PROJECT: Multiple Buildings – Roof Replacement

Woodward Hall

NO.: 02

DATE OF ISSUANCE: 4/2/2024

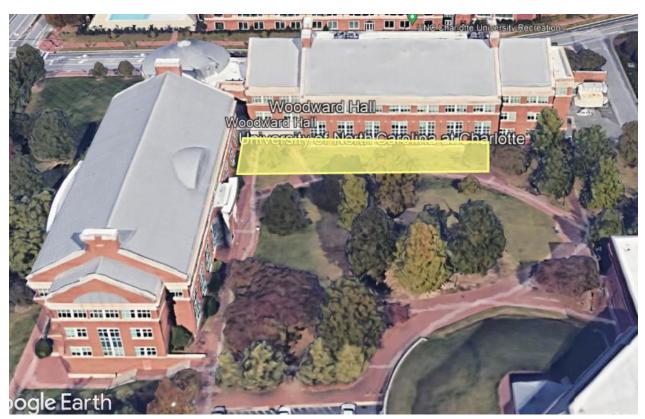
1. Would it be possible to stage a crane and/or dumpster in highlighted yellow area?

A dumpster could be staged in highlighted yellow area if the path to the area is properly protected. Please note the brick paver pathway surrounding the building is not vehicle rated and any damage to pavers, landscaping, etc. shall be repaired by the Contractor at their expense if these are utilized by vehicles/equipment during the project.
